REGULATORY INFORMATION DISTRIBUTION SYSTEM (RIDS)

SUBJECT: Requests mod to 841025 exemption from 10CFR50, App R re
component cooling water pump room, per 840425 ltr.

H. B. ROBINSON STEAM ELECTRIC PLANT, UNIT NO. 2
DOCKET NO. 50-261/LICENSE NO. DPR-23
CCW PUMP ROOM EXEMPTION

H. B. ROBINSON UNIT NO. 2 COMPONENT COOLING WATER PUMP ROOM EXEMPTION AMENDMENT

FIGURE 2

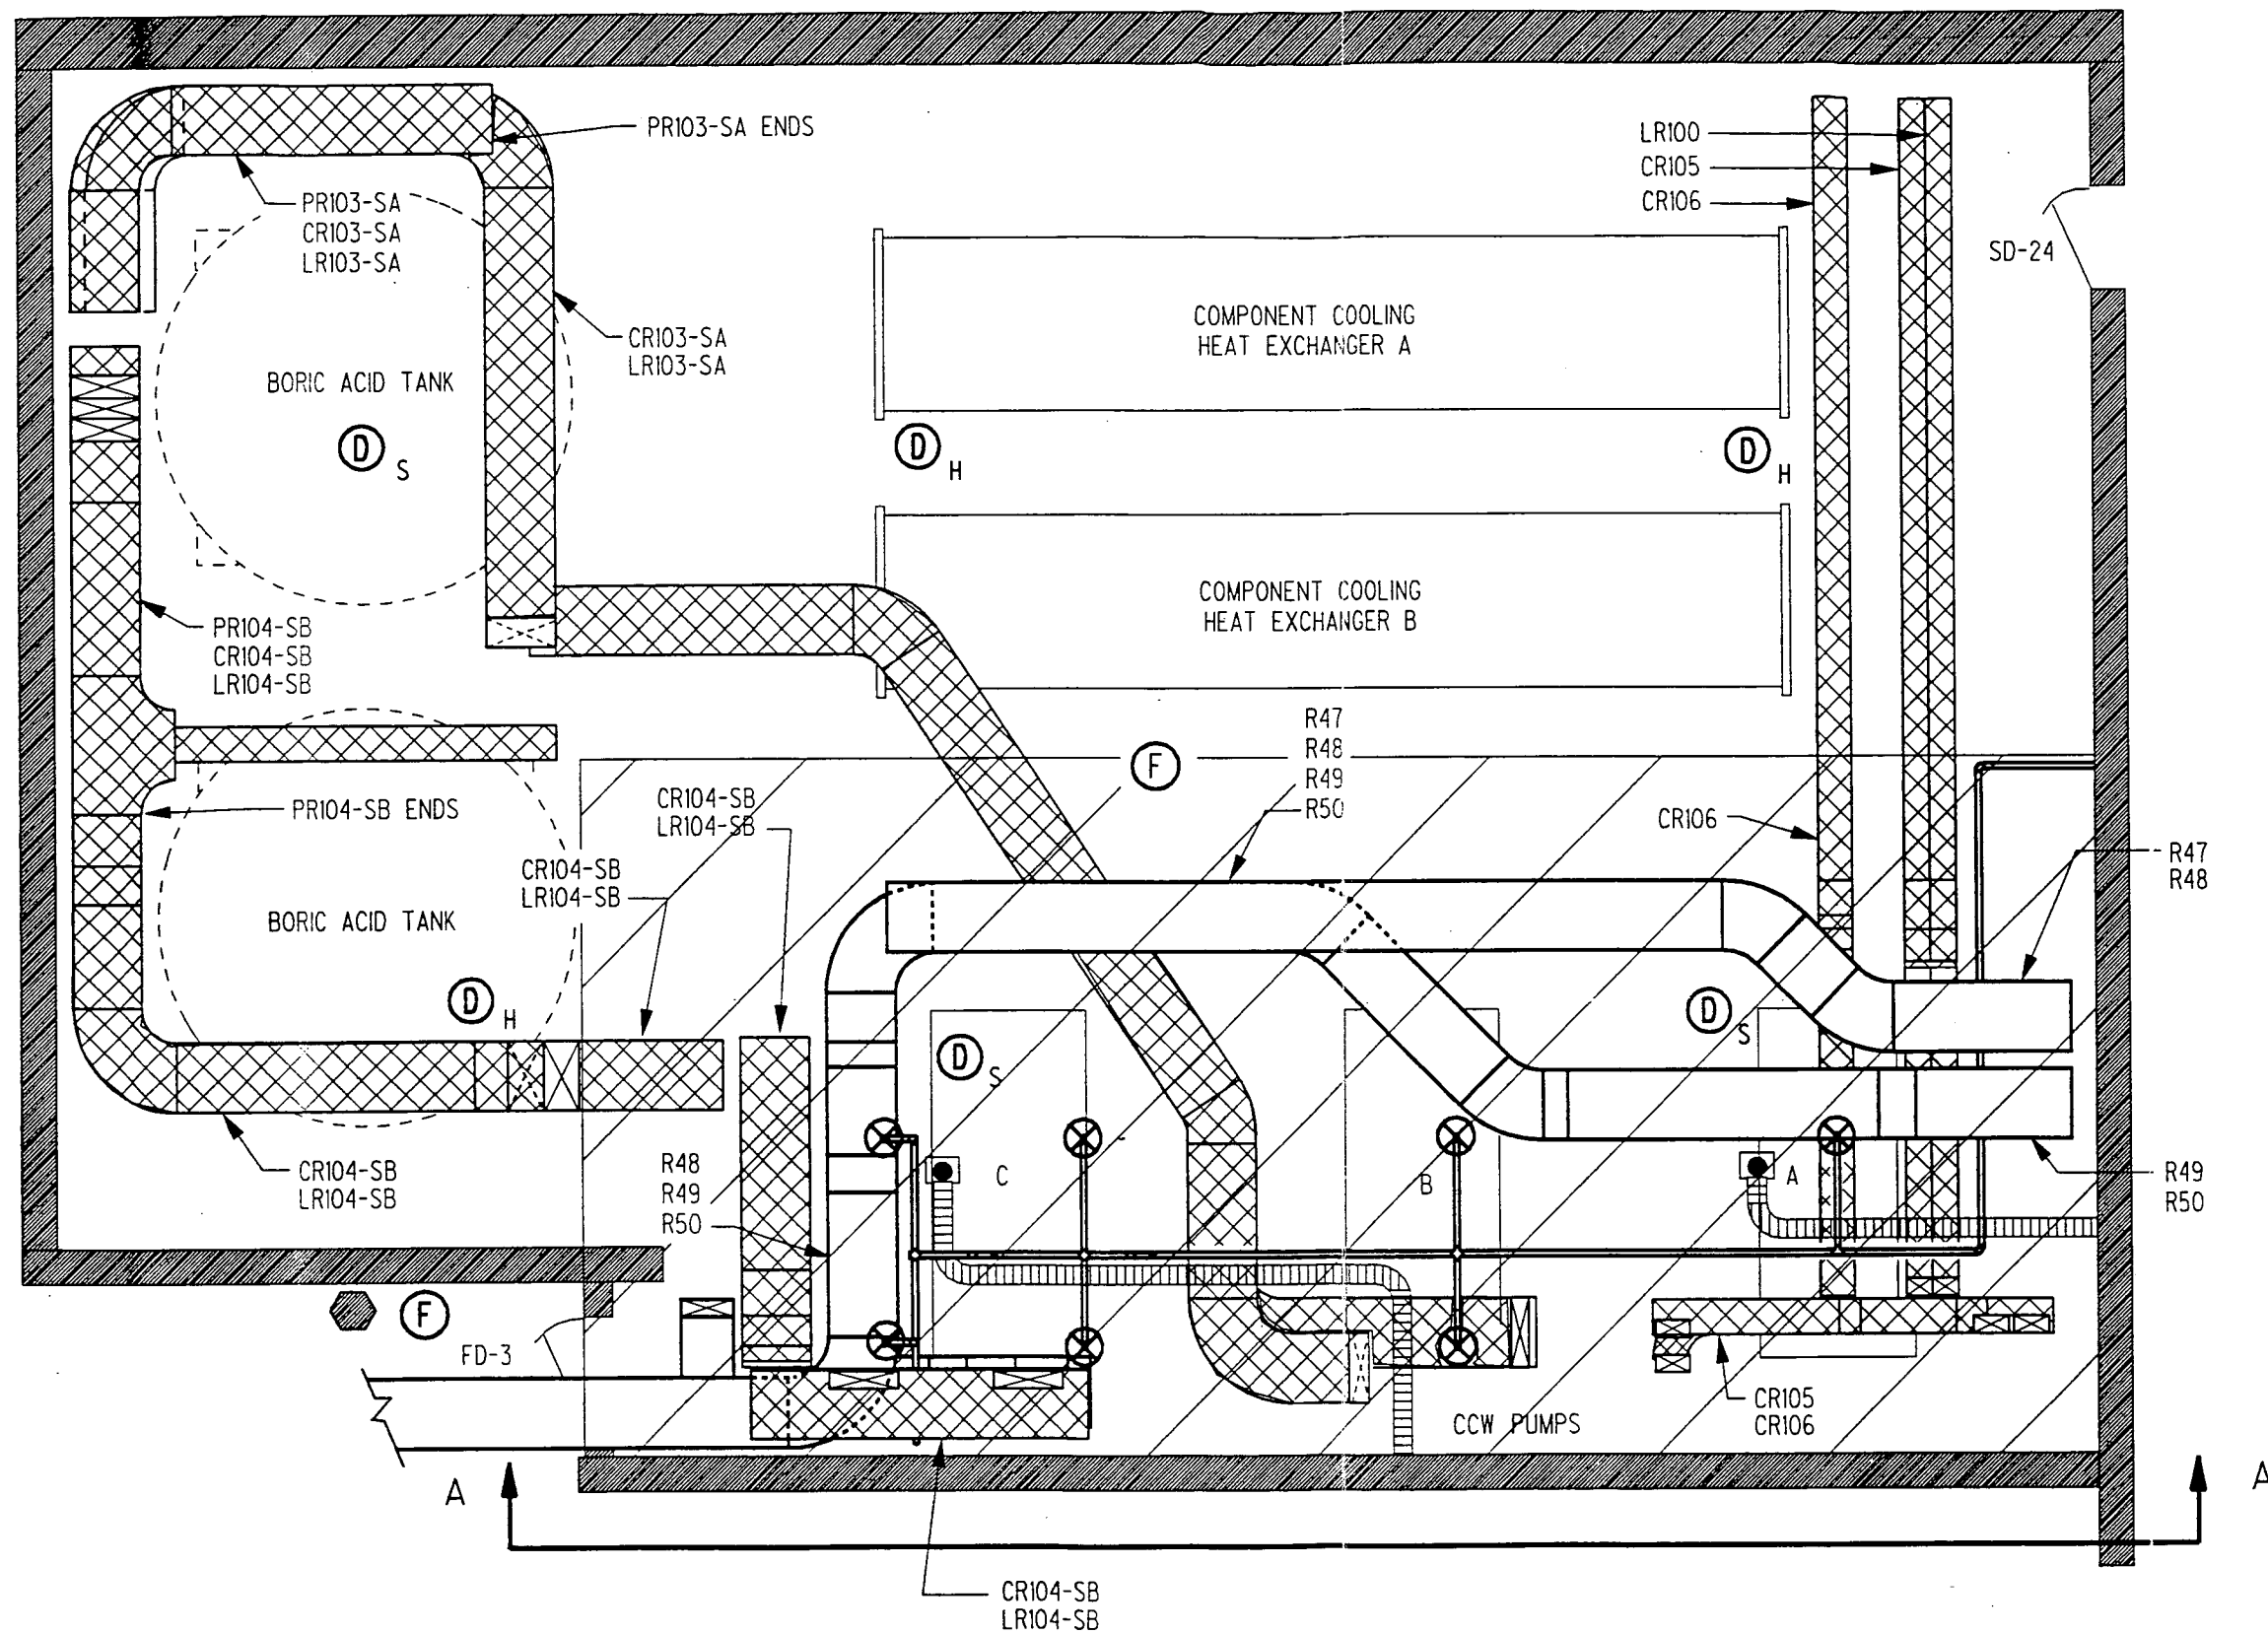
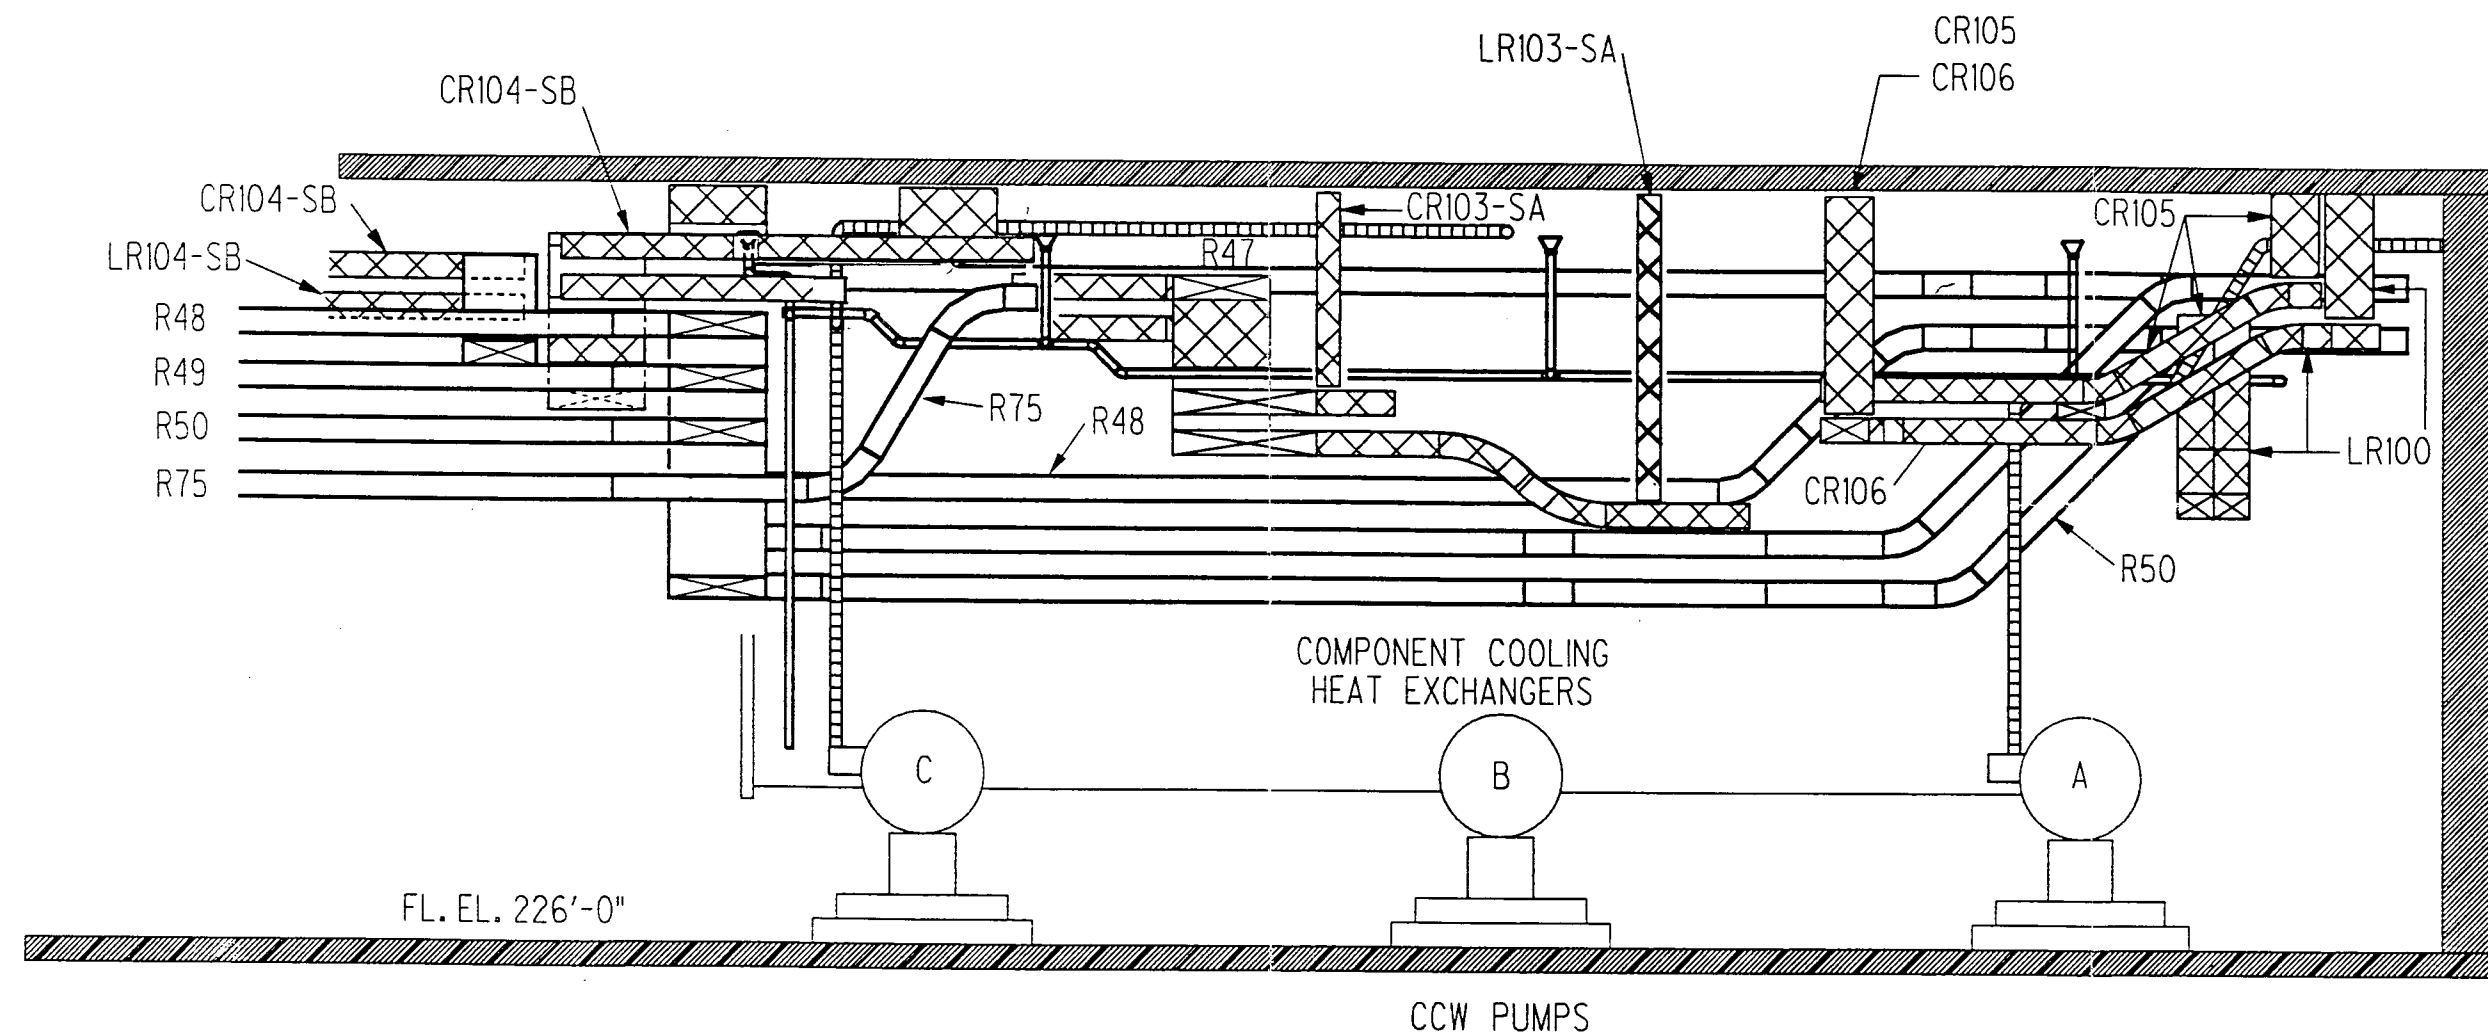
As shown in Figures 2 and 3, CP&L plans to install new cable trays in the CCW pump room. Cables installed in these trays will be qualified to IEEE-383, Vertical Flame Test.

If these cable trays are eventually filled with the maximum allowable cable loading, the proposed installation of the new cable trays would introduce additional cable combustible loading of approximately 100,000 Btu/ft², which would be equivalent to a fire severity of approximately 75 minutes. However, through existing design control, CP&L will ensure that the in-situ combustible fire severity in the area does not exceed 60 minutes. At that point, measures will be taken to preclude an increase in combustibles loading above 60 minutes or to provide additional appropriate fire protection features.

The fire severity in the Component Cooling Water Pump Room will not exceed 60 minutes without additional fire protection features being provided.

FIGURE 4

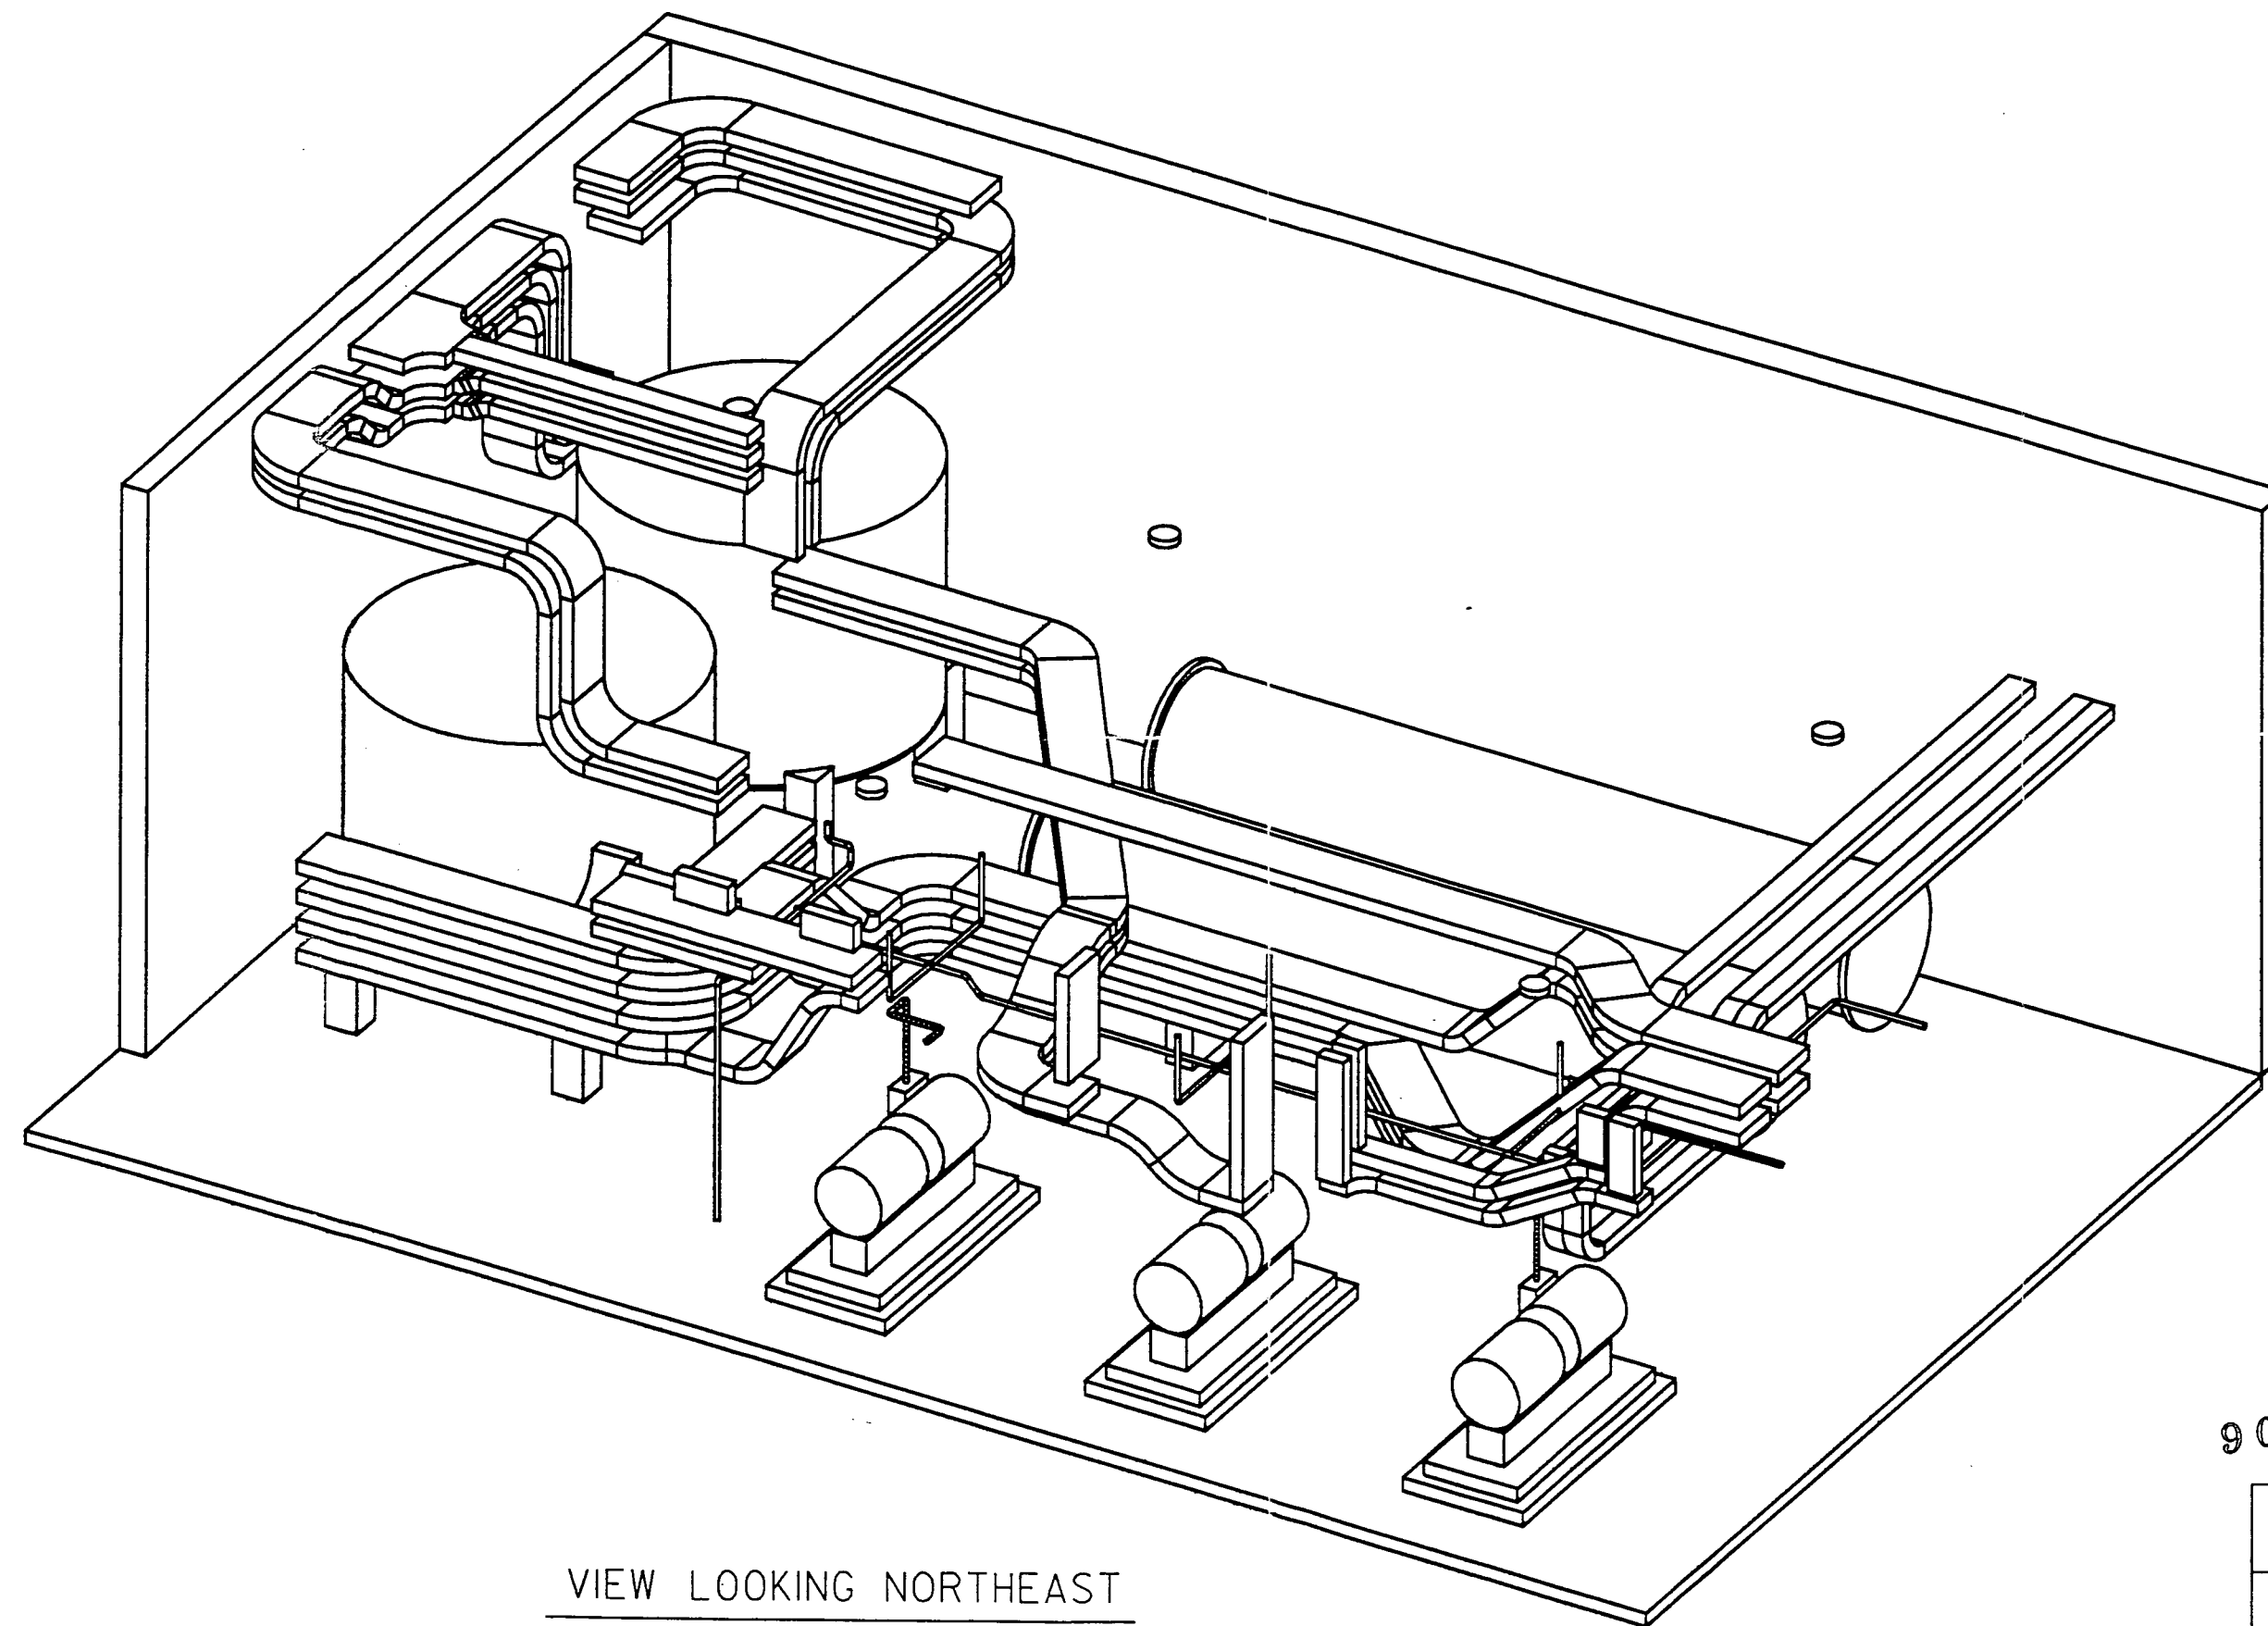
cable combustibles into the CCW pump room. The composite final proposed 3-D view is shown in Figure 4 of this letter for reference.
